Architect's Supplemental Instructions

Architect's ASI No: 029

Project:
Webster University
Interdisciplinary Science
Building

1. EG102 – Environmental Graphics
 - A. Omit “W” with 1/16” Naval brass with satin finish on all levels.

EG1-Overall Multi-Level Feature Wall

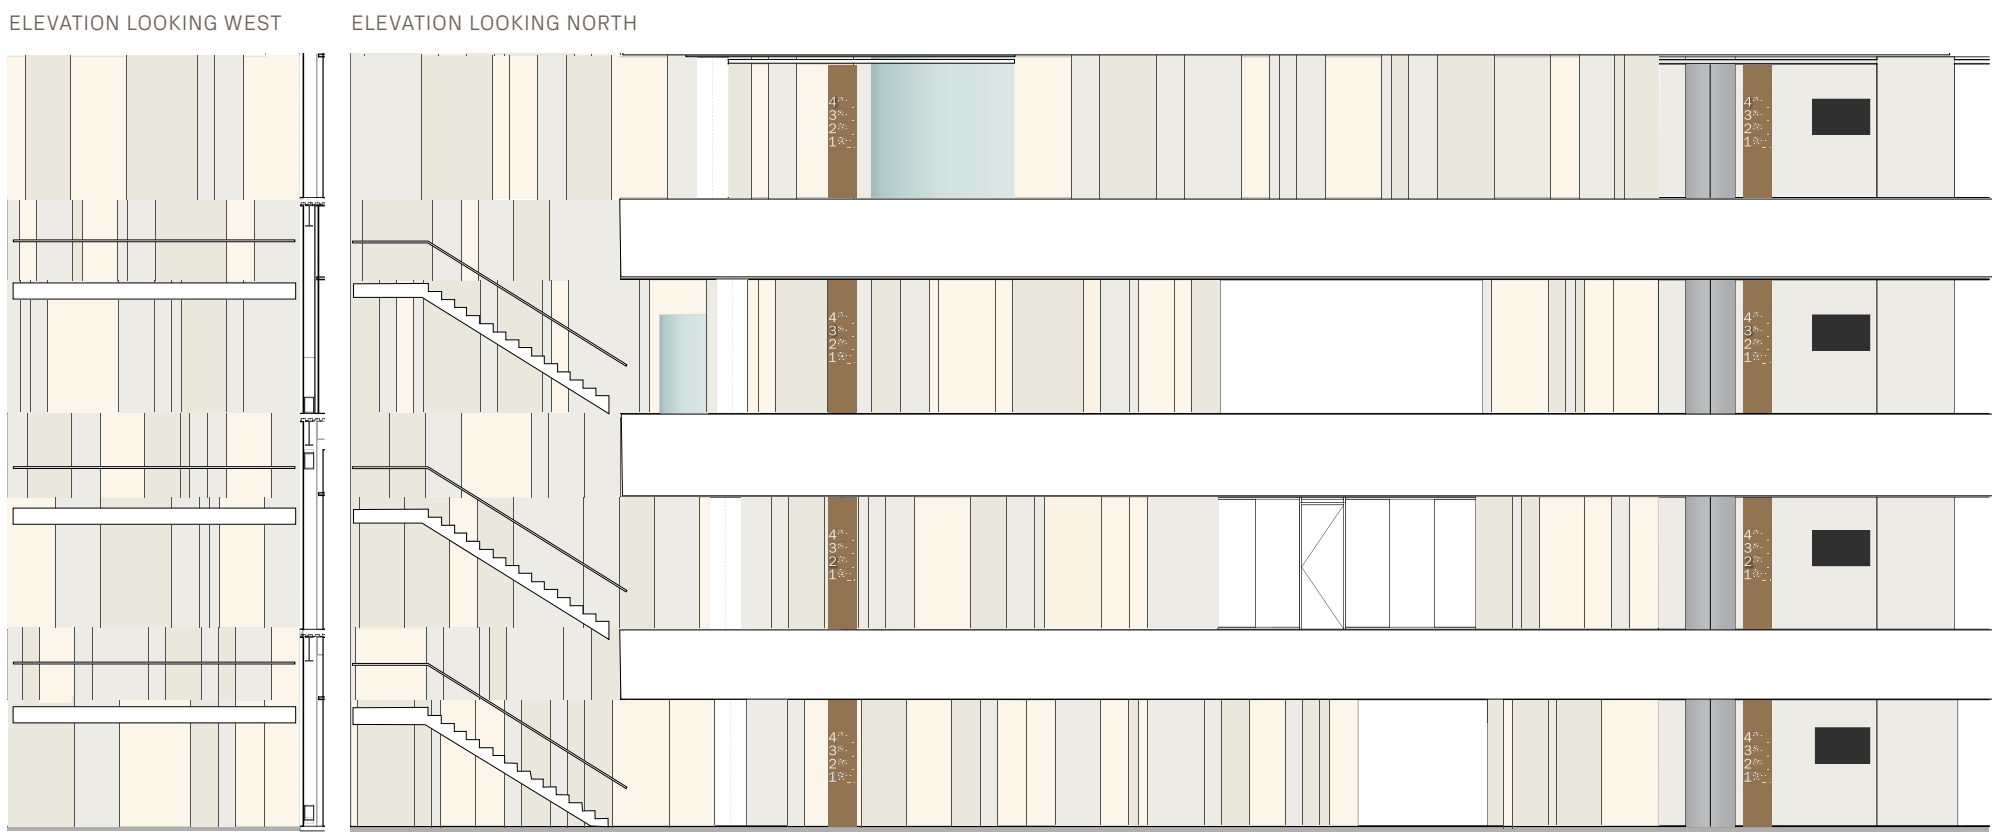
This information is no longer in scope

EG1-111 Multi-Level Feature Wall

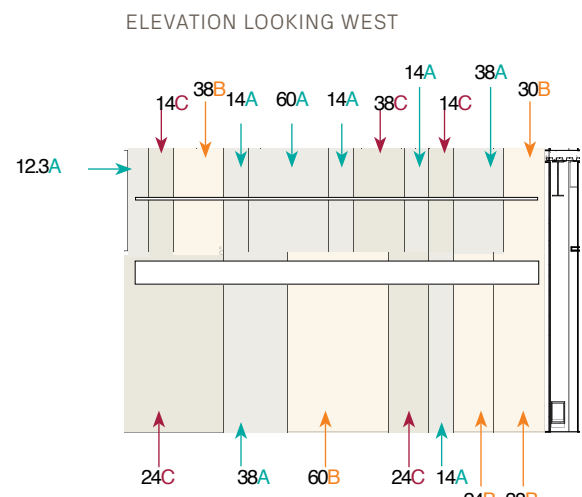
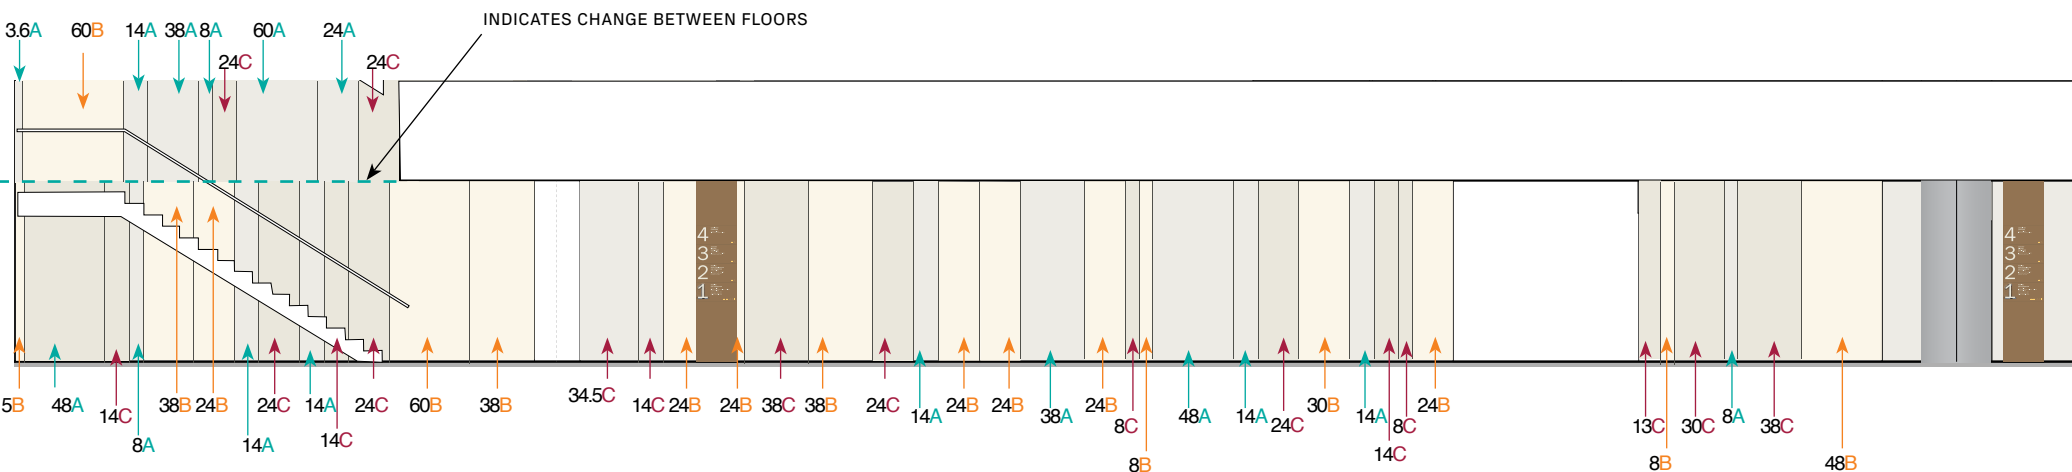
This information is no longer in scope

EG1-214 Multi-Level Feature Wall

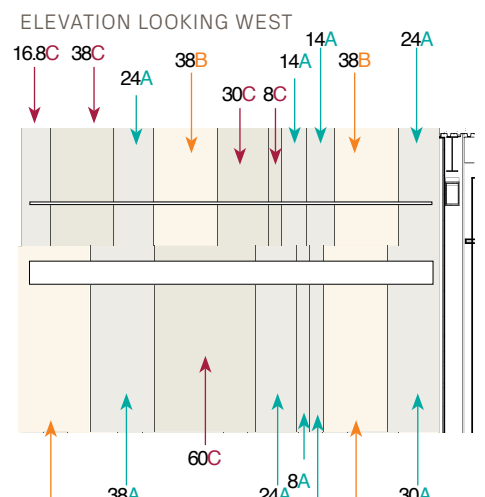
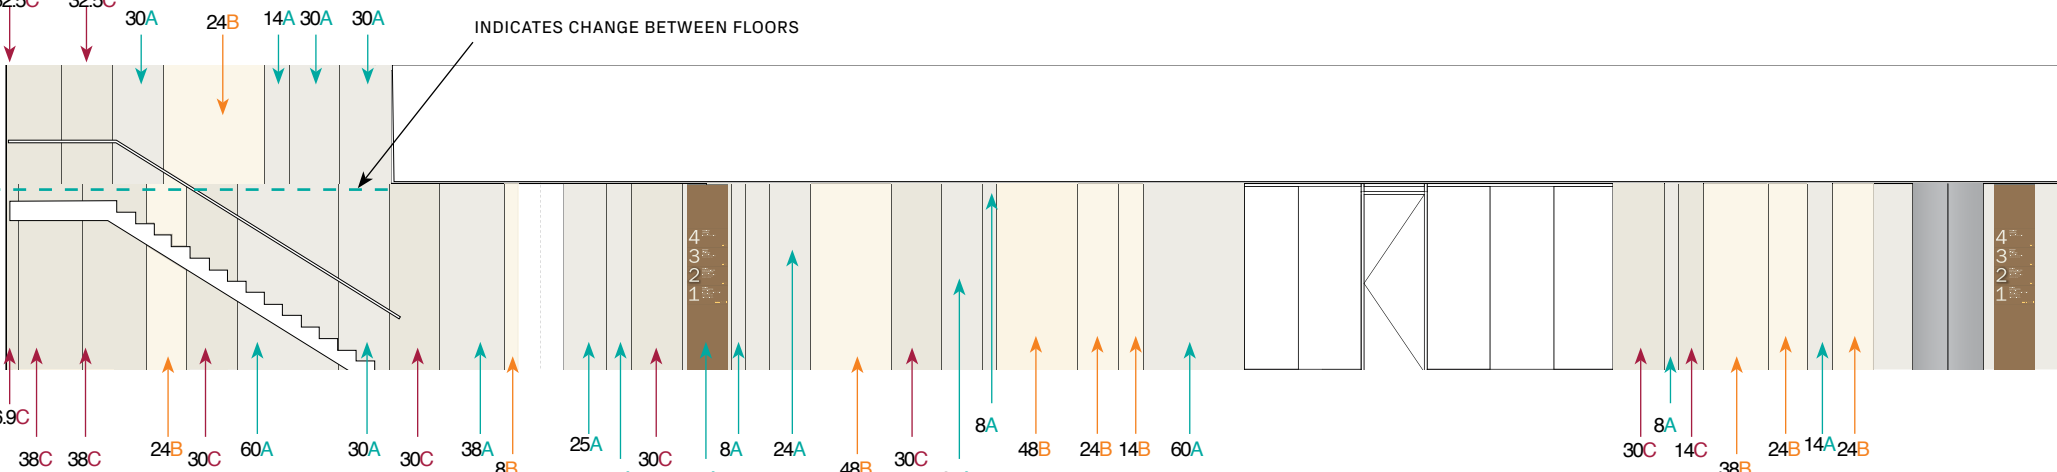
This information is no longer in scope

EG1-303 Multi-Level Feature Wall

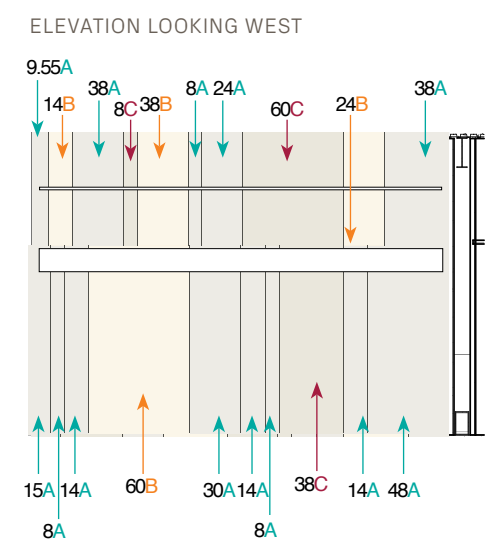
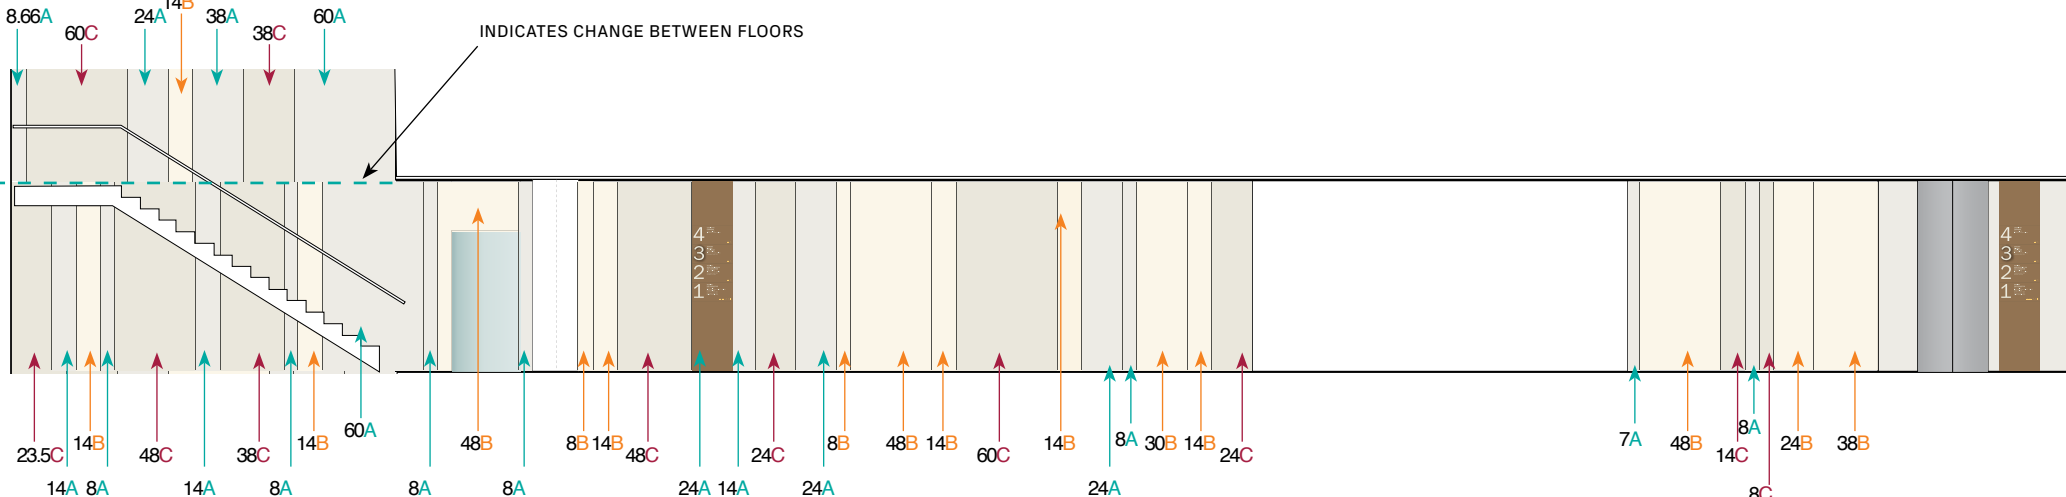
This information is no longer in scope

EG1-409 Multi-Level Feature Wall

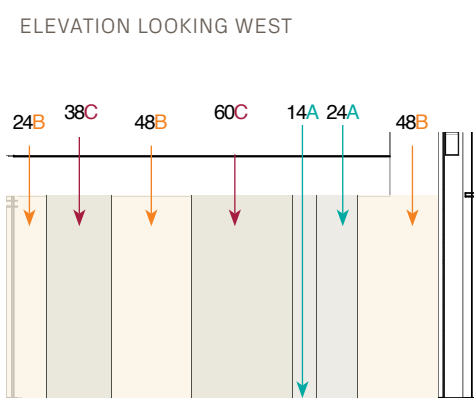
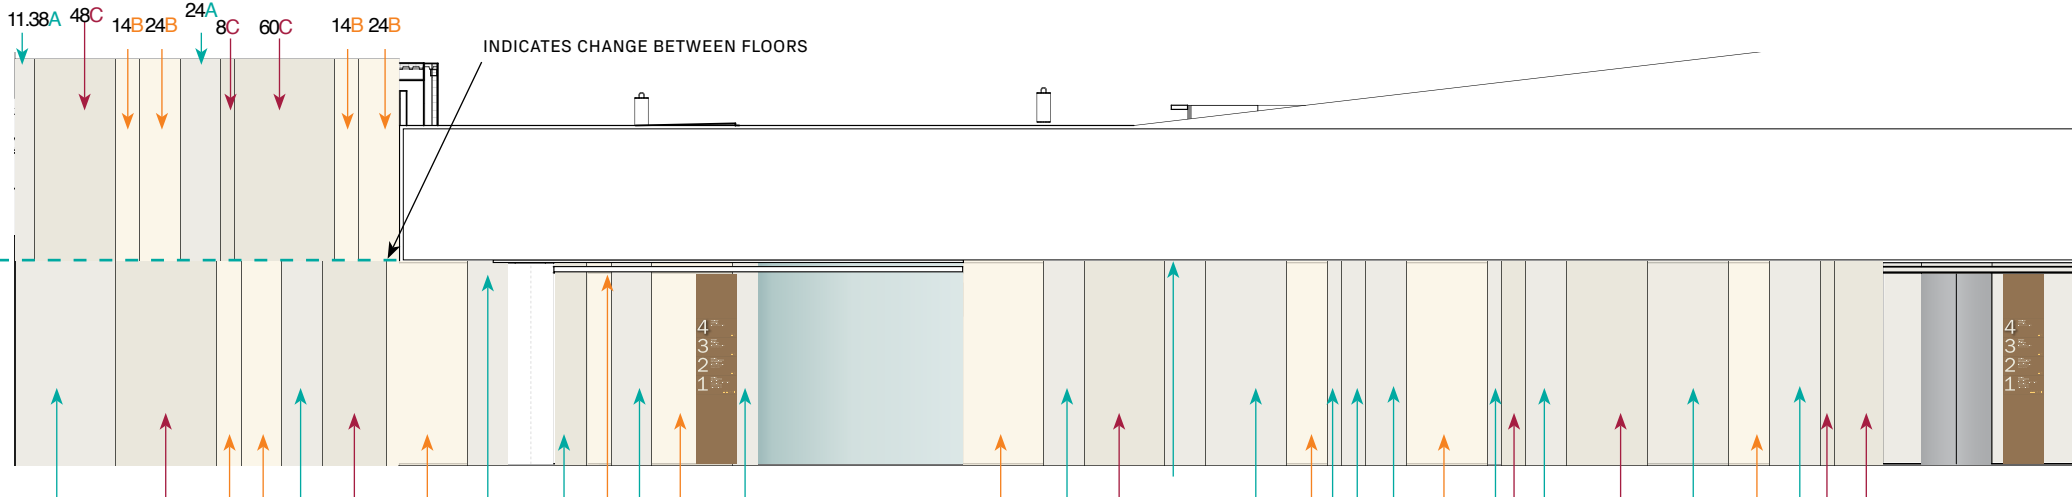
This information is no longer in scope

"W" with 1/16" Naval brass with satin finish on all levels has been removed. Painted MDF should run floor to ceiling in the areas that the "W" previously ran.
